U.S. NUCLEAR REGULATORY COMMISSION
REGION I

Report No. 50-219/85-28

Oyster Creek Nuclear Generating Station

Inspection Summary: Inspection on September 23-27, 1985
(Report No. 50-219/85-28)

ATTACHMENT 5
TRANSFORMER INSTRUMENTATION

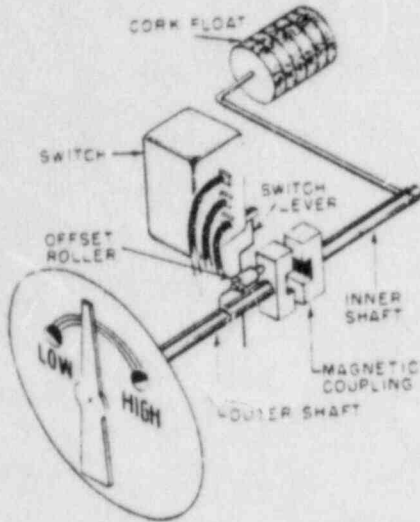
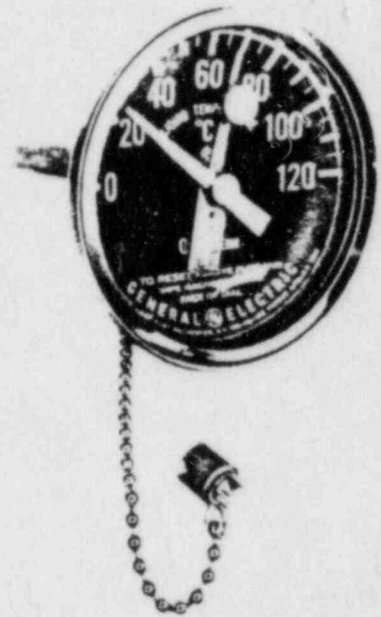
Some problems with instrumentation were discovered during the licensee's investigation. The liquid temperature indicator on the 1A2 transformer did not give an accurate reading of the oil temperature. This also contributed to the event in that the instrument was not accurately indicating the status of the transformer. The temperature indicator is installed in a cooling fin tube header. To display an accurate liquid temperature reading, its sensor must be submerged in the transformer oil. This particular cooling fin tube header was one of those that did not receive any oil flow as a result of the low oil level. During licensee testing of the vital transformer, a portable pyrometer was used to measure the oil temperature. Once the oil flow in the cooling fin with the installed temperature device was established, the pyrometer and installed temperature sensor compared favorably. With the newly established higher levels in the transformers, this problem will not exist because the sensors of the liquid level indicators will be submerged in oil all the time.

Another instrument problem was the liquid level gauge. The accuracy of the level gauge required to sense small level changes in the transformer cooling headers is critical. The present level gauge may not have the required accuracy to indicate these small level changes in the cooling header to the extent that an operator could determine the onset of cooling degradation. In addition, the level indicator is not graduated to show the normal levels at various temperatures. It shows an acceptable range of level with minimum and maximum levels, the center point being the nominal level at 25°C (see Attachment 5). With the newly established higher levels in the transformers, the licensee plans to recalibrate the liquid level gauges to provide an accurate indication of the expected levels at various operating temperatures, or alternatively, provide a table or chart so that the operator can immediately determine if the levels are within acceptable limits.

Item 2 involves development of sampling and filling procedures and guidances. This item also includes the recalibration of the liquid level gauges to provide proper operator guidance on its use. The licensee committed to complete this item by the end of the April 1986 refueling outage.

ATTACHMENT 6
SKETCH OF TRANSFORMER SHOWING THE NOMINAL OIL LEVEL

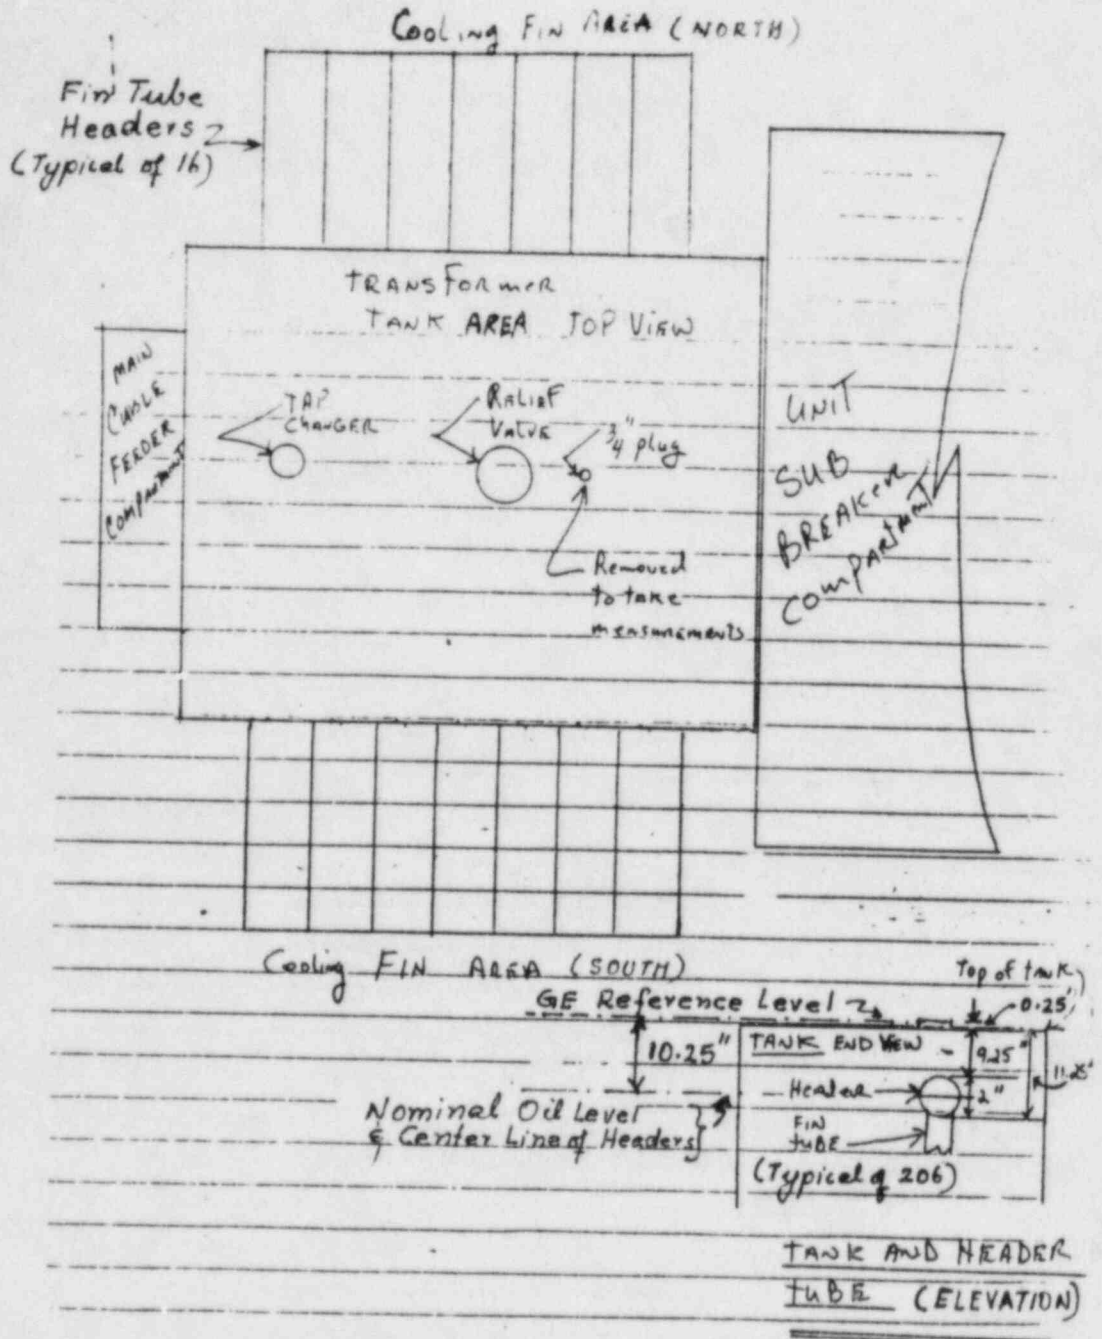
The transformers are rated for a 65°C rise over an ambient of 30°C. The nominal liquid level at 25°C is 10.5 inches below the reference point which is 0.25 inches above the top of the tank (See Attachment 6). The nominal nitrogen pressure is approximately 2-3 psig. The relief valve is set to relieve the nitrogen pressure if it exceeds 5 psig.

During the subsequent filling operation, the licensee measured the actual transformer oil levels and temperatures and back-calculated the equivalent levels at 25°C based on the name plate data of 0.39 inches rise in level/10°C rise. The calculated levels at 25°C were 11.63 inches and 11.42 inches for 1A2 and 1B2, respectively, below the top of the tank (See Reference 15). These values are equivalent to 11.88 and 11.67 inches below the GE reference level shown in Attachment 6. These levels are 1.38 and 1.17 inches less than the nominal value of 10.5 inches below the reference level. The above as-found levels are also insufficient to establish natural convection flow through all tubes at normal operating temperatures, as evidenced during the event. As discussed below, the amount of oil withdrawn from the transformers as test samples does not account for the low level condition. Apparently this condition existed since the original plant installation.

The final levels in 1A2 and 1B2 transformers were 8.25 inches at 44°C and 8.875 inches at 46°C below the General Electric reference point. These values when corrected to 25°C, work out to be 8.99 inches and 9.69 respectively compared to 10.25 inches nominal level indicated on the transformer name plate. Therefore, the final levels in 1A2 and 1B2 transformers at 25°C were 1.51 and 0.80 inches above the nominal level. At the newly established final levels, the top fin tube headers will be covered and the transformers will have convection cooling flow through all fins at all operating temperatures. The licensee has requested General Electric to review the adequacy of the newly established levels and their cooling problem in general (References 14 and 15).

ATTACHMENT 7
SKETCH OF FIN TUBES SHOWING FLOW
BEFORE AND DURING LOAD TEST ON 1A2

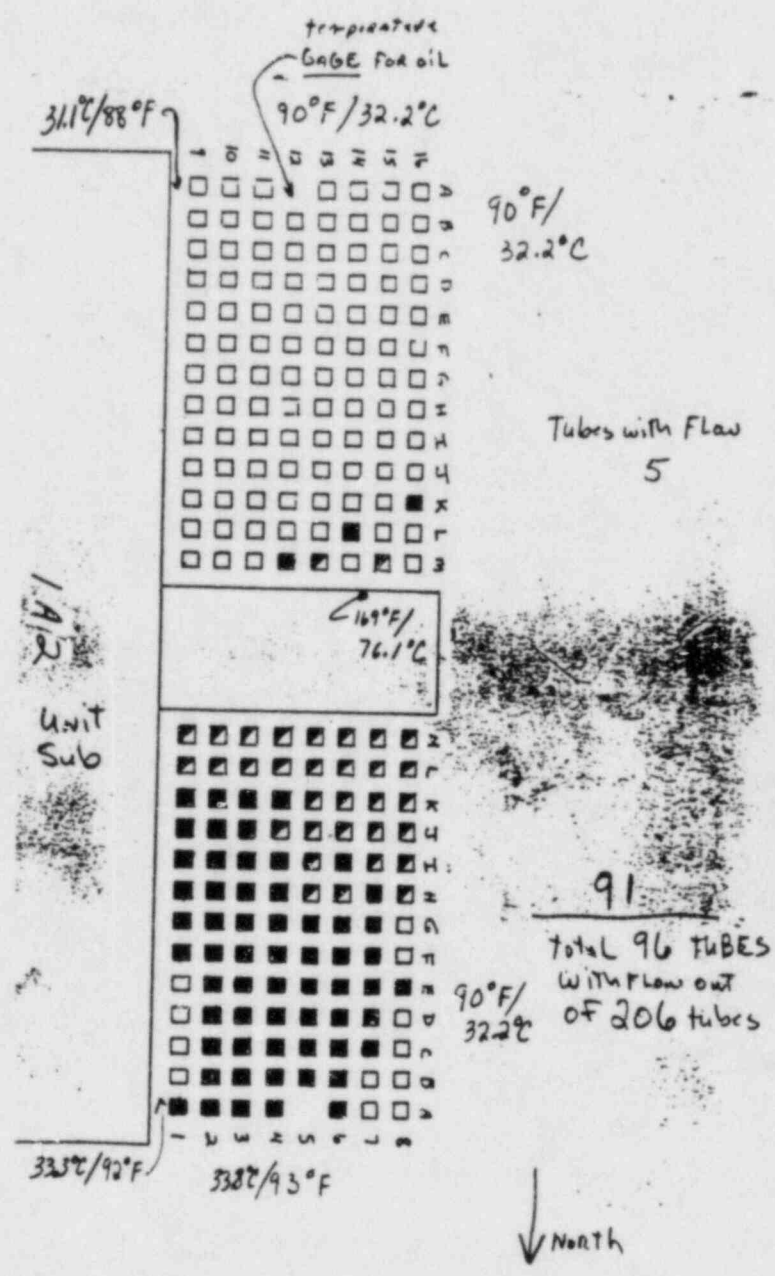
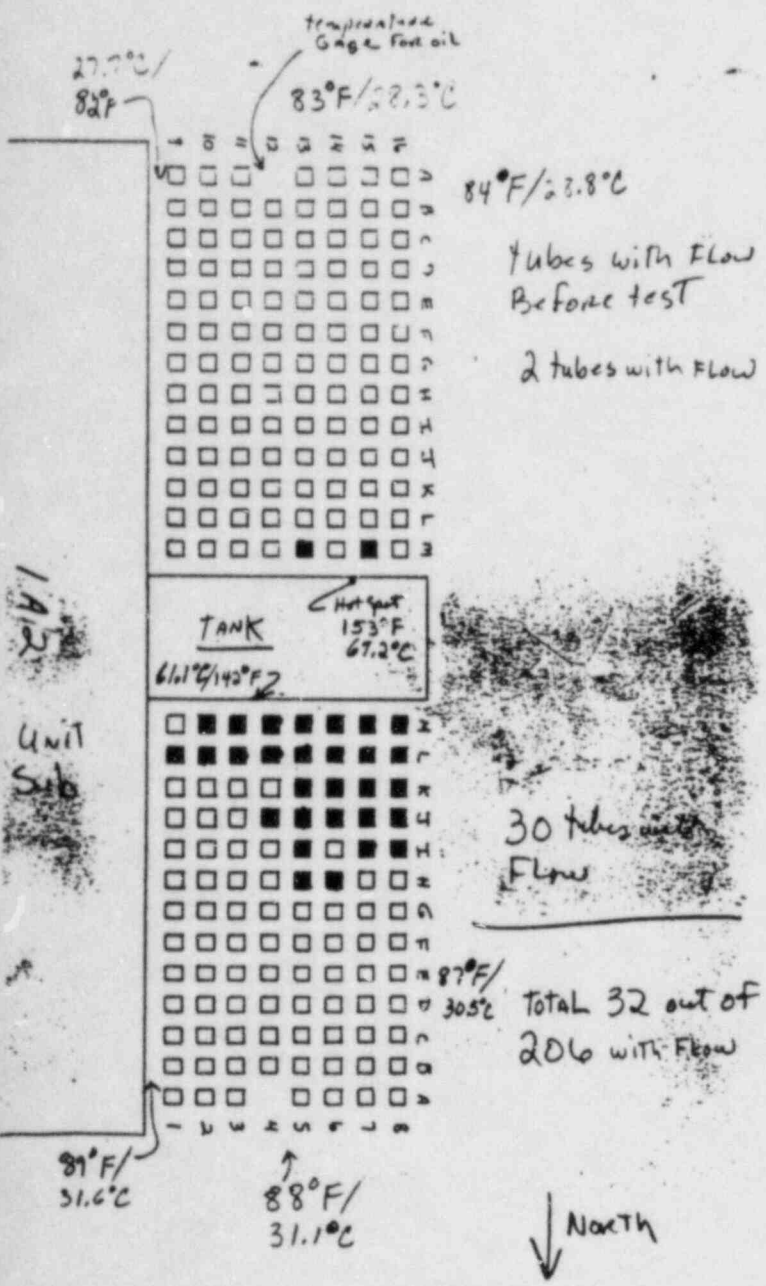
The 1A2 transformer was chosen because thermographic photographs indicated that it had less oil flow in its fin tubes than 1B2. The load test on 1A2 was conducted on August 8, 1985. During the test, it was noticed that the liquid temperature gauge located on a top fin tube header did not move from the 32°C mark. The tank temperature was 76.1°C, as measured with a contact pyrometer. Prior to the test, 32 out of a total of 206 tubes had flow; and after the test, an additional 64 tubes had flow (see Attachment 7). This indicated that, at higher loading of the transformer with resultant heating and volume increase of the oil, more tubes received flow of oil.

In addition to the insufficient oil levels in both transformers, 1A2 transformer installation was off-level by 1/2 inch vertically over the width of the transformer (approximately 8-feet). This was the reason one side of the 1A2 transformer had significantly more tubes having flow than on the other side, as observed during the thermographic observations (See Attachment 7). However, the contribution to the event by this condition is determined to be less significant than those discussed previously.

ATTACHMENT 8
THERMOGRAMS OF 1B2 SHOWING OIL FLOW BEFORE, DURING,
AND AFTER FILLING

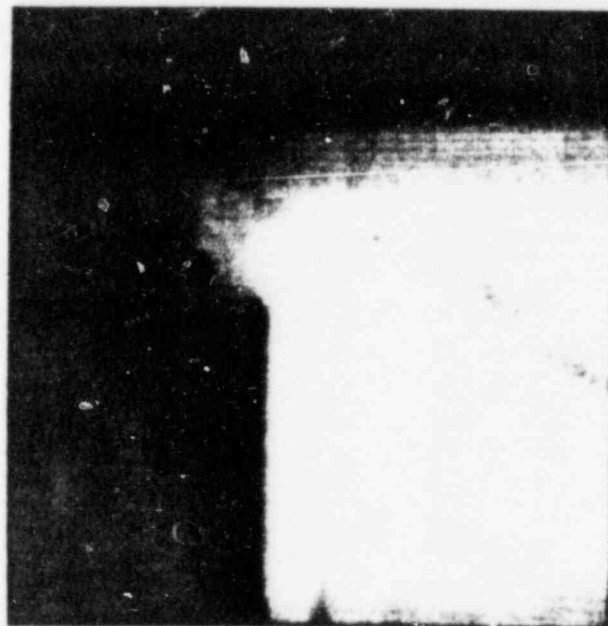
Explanatory Note: Figure 1 is a normal photograph of south side cooling fins of 1B2. Figures 2, 3, and 4 are thermograms of the same before, during, and after filling. Dark area in Figure 2 indicates lack of flow in the left side tubes. Figure 3 shows partial establishment of flow in these tubes during filling. Figure 4 shows the flow fully established.

The immediate corrective action taken was to initiate an orderly plant shutdown and then add oil to unit substation transformers 1A2 and 1B2. Sixteen (16) gallons of transformer oil were added to the 1A2 transformer. Twelve (12) gallons of transformer oil were added to the 1B2 transformer. After the oil was added, thermographic photographs were taken which verified that all cooling fins in both transformers had proper oil flow. The four (4) non-essential unit substation transformers at the site (1A1, 1A3, 1B1, and 1B2) were also tested and found to be in satisfactory condition.
